Technical Service Bulletin

SUBJECT: UPDATED SRS PROCEDURES FOR SEAT SLIDE SENSOR & SEAT BELT SWITCH – SERVICE MANUAL REVISION		No: TSB-17-52B-003	
		DATE: October 2017	
		MODEL: 2014-15 Mirage	
CIRCULATE TO:	<input type="checkbox"/> GENERAL MANAGER	<input checked="" type="checkbox"/> PARTS MANAGER	<input checked="" type="checkbox"/> TECHNICIAN
<input checked="" type="checkbox"/> SERVICE ADVISOR	<input checked="" type="checkbox"/> SERVICE MANAGER	<input type="checkbox"/> WARRANTY PROCESSOR	<input type="checkbox"/> SALES MANAGER

This TSB updates the Supplemental Restraint System (SRS) section of the affected Service Manuals to include seat slide sensor and seat belt switch information.

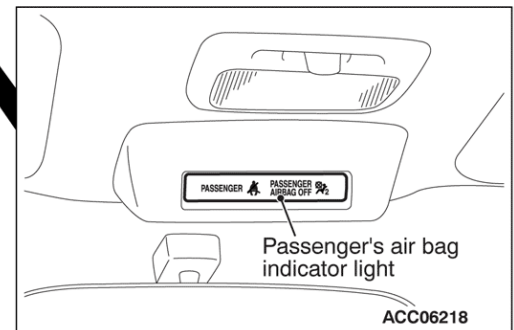
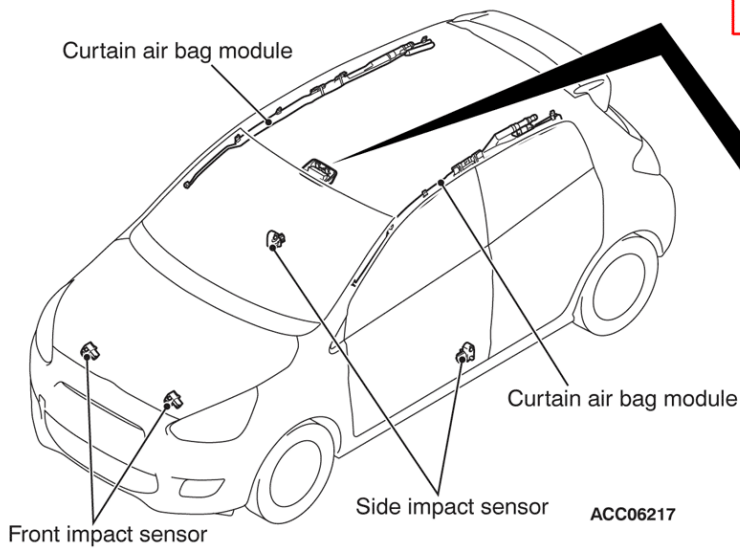
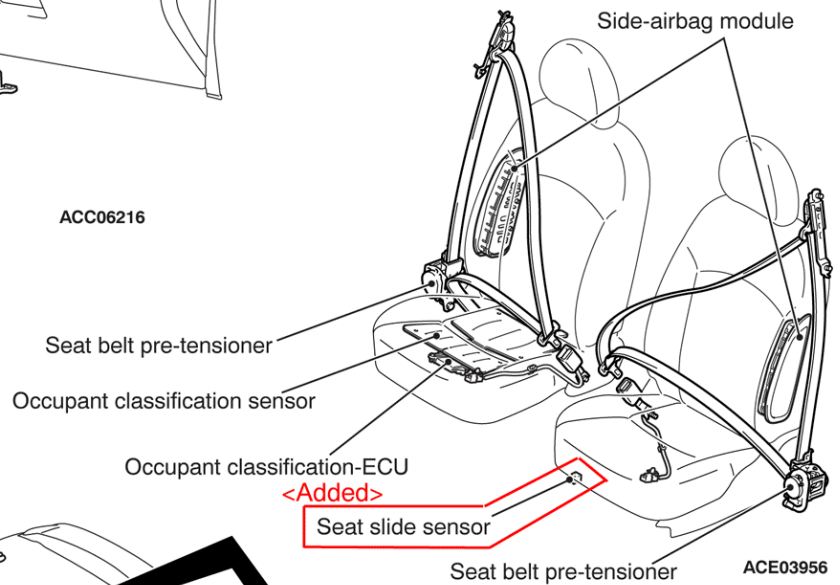
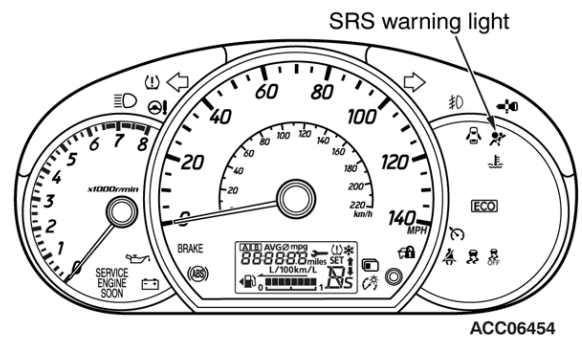
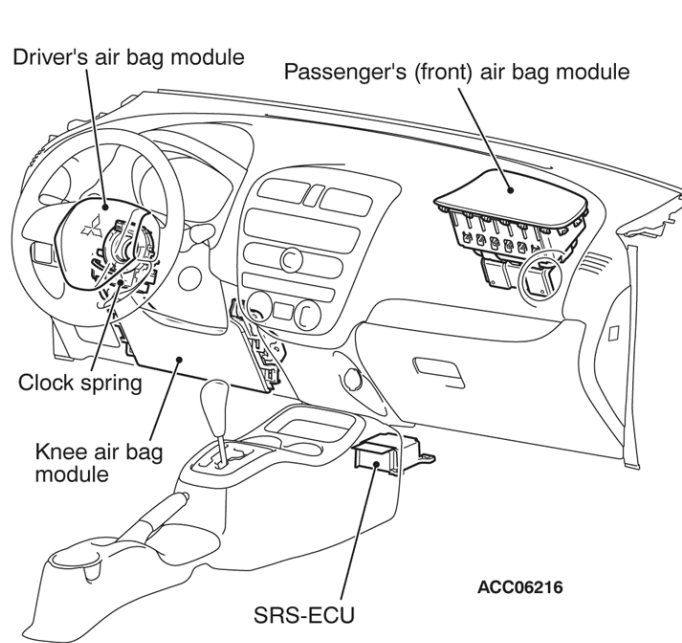
The SRS* consists of driver's and passenger's (front) air bag modules, knee air bag module, side-airbag modules, curtain air bag modules, SRS* air bag control unit (SRS-ECU), two front impact sensors, two side impact sensors, SRS* warning light, passenger's air bag OFF indicator light, passenger's seat belt warning light, clock spring, seat belt pre-tensioner, seat belt buckle switch, occupant classification sensor and occupant classification-ECU.

<Added>
seat slide sensor,

Driver's and passenger's (front) air bag modules are located in the center of the steering wheel and above the glove box. The knee air bag module is installed to the instrument panel cover lower under the steering column. Side-airbags are located inside the front seatback frame. The curtain air bag module consists of an air bag, an inflator, and the fixing gear relating to those parts, and is installed in the roof side sections (from the driver's and the passenger's front pillars to the rear pillars). Each air bag consists of a folded air bag and an inflator unit. The SRS-ECU placed on the forefront of the floor monitors the system and has a front air bag analog G-sensor and a side-airbag analog G-sensor. The front impact sensor is assembled in the front end upper bar in the engine room to monitor impact in case of front impact. The side impact sensors inside the center pillars monitor the shock incurred by the sides of the vehicle. The SRS* warning light on the combination meter indicates the operational status of the SRS*. The clock spring is installed in the steering column. The seat belt pre-tensioner is built into the driver's and passenger's front seat belt retractor. The occupant classification sensor is installed underneath a rail of the passenger seat to detect the load on the seat. The passenger's air bag OFF indicator light is installed to the headlining, and illuminates when the passenger seat airbag is inactive. The passenger's seat belt warning light is installed to the headlining, and illuminates when the passenger is not wearing the seat belt. The seat belt switch detects whether the seat belt is used.

<Added>

The seat slide sensor is attached to the slide adjuster on the driver's seat side.

STEP 3. Resistance measurement at the SRS-ECU connector and the seat slide sensor connector.

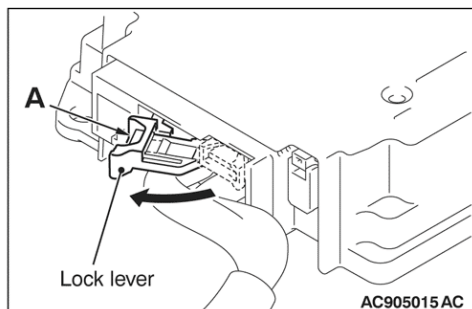
- (1) Check that the negative battery terminal is disconnected. If the negative battery terminal is connected, disconnect it.
- (2) While pushing the part "A" indicated in the figure of the harness side connector, turn the lock lever to the direction of the arrow to release the lock lever, and disconnect the SRS-ECU connector.
- (3) Disconnect the seat slide sensor connector.

Do not insert a probe into the terminal from seat slide sensor connector harness side connector front side directly, as the connector contact pressure may be weakened.

- (4) Check for continuity between the following terminals. It should be less than 2 ohms.
 - Continuity DS1- line between SRS-ECU wiring harness side connector and the seat slide sensor connector
 - Continuity DS1+ line between SRS-ECU wiring harness side connector and the seat slide sensor connector

NO : Repair harness wires DS1-, DS1+ line between SRS-ECU connector and the seat slide sensor connector. Then go to Step 7.

STEP 4. Check the harness short circuit between seat slide sensor connector and the SRS-ECU connector.

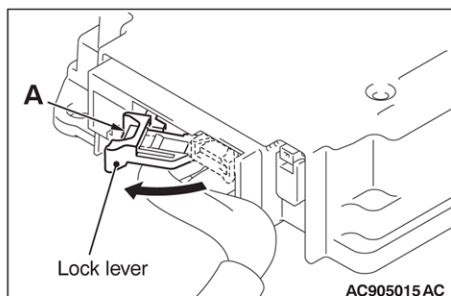
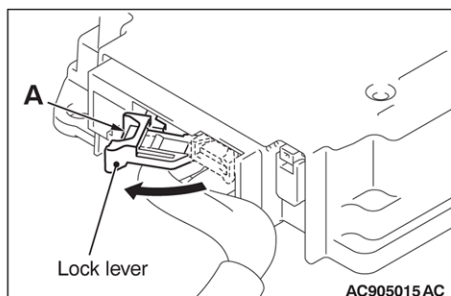
- (1) Disconnect the negative battery terminal.
- (2) Disconnect the seat slide sensor connector.
- (3) While pushing the part "A" indicated in the figure of the harness side connector, turn the lock lever to the direction of the arrow to release the lock lever, and disconnect the SRS-ECU connector.
- (4) Measure the resistance between DS1-, DS1+ line and body ground. It should be less than 2 ohms.

NO : Repair the harness wires DS1-, DS1+ line between SRS-ECU connector and the seat slide sensor connector. Then go to Step 7.

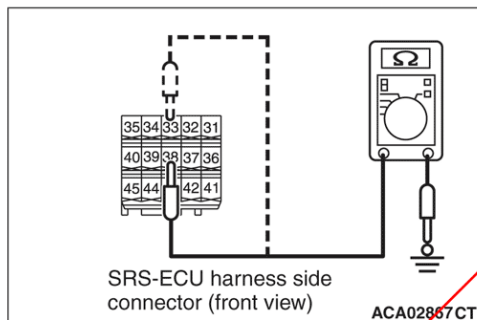
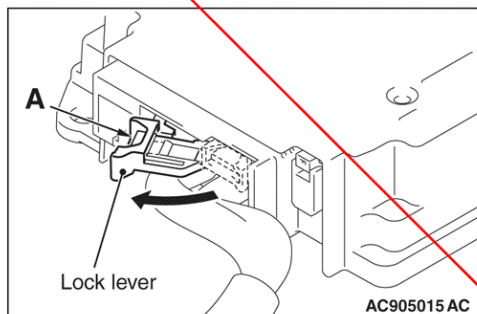
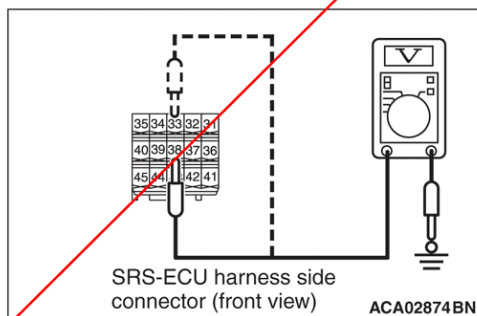
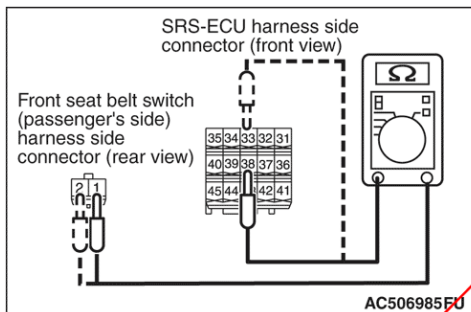
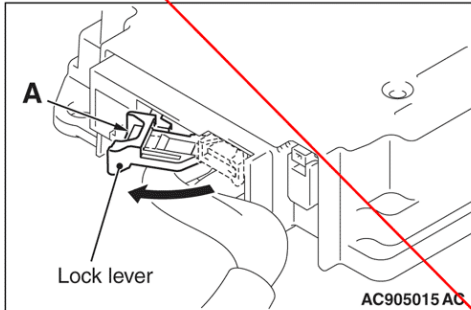
<Incorrect>

<Incorrect>

<Incorrect>

STEP 4. Check the harness short circuit between seat belt switch (passenger's side) connector and the SRS-ECU connector.

- (4) Measure the resistance between PBS-, PBSO line and body ground (No. B1537 only). It should be an open circuit.

<Incorrect>

STEP 5. Resistance measurement at the SRS-ECU connector and the seat belt switch (passenger's side) connector.

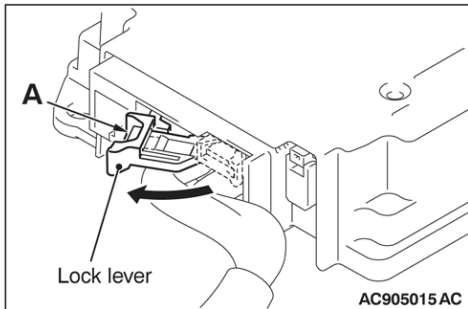
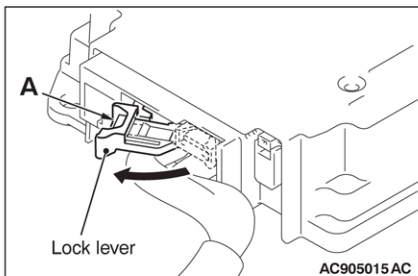
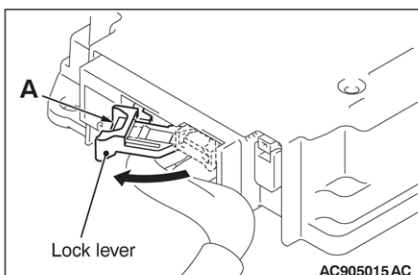
<Correct>

<Correct>

STEP 3. Resistance measurement at the SRS-ECU connector and the seat belt switch (passenger's side) connector.

- (4) Check for continuity between the following terminals. It should be less than 2 ohms.
 - Continuity PBS- line between SRS-ECU wiring harness side connector and the seat belt switch (passenger's side) connector
 - Continuity PBSO line between SRS-ECU wiring harness side connector and the seat belt switch (passenger's side) connector

<Correct>

STEP 4. Check the harness short circuit between seat belt switch (passenger's side) connector and the SRS-ECU connector.

SEAT SLIDE SENSOR

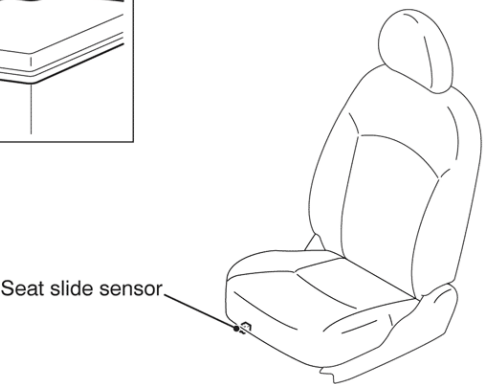
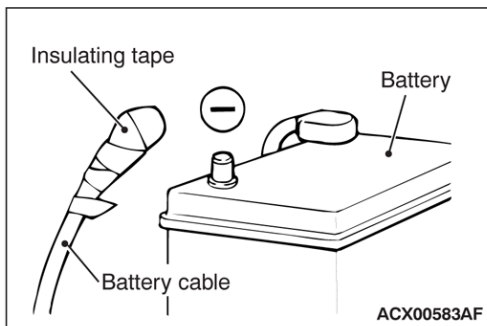
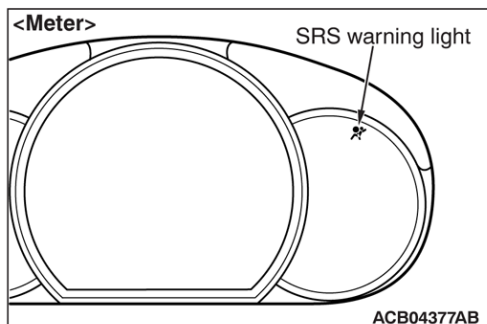
Please add the following information as a new section after the “Side Impact Sensor” section to the 2014 and 2015 Mirage Service Manual, Group 52B – Supplemental Restraint System (SRS).

REMOVAL AND INSTALLATION

- **Never attempt to disassemble or repair the seat slide sensor. If faulty, replace it.**
- **Do not drop or subject the seat slide sensor to impact or vibration. Replace the seat slide sensor, if dents, cracking, deformation, or rust are present.**
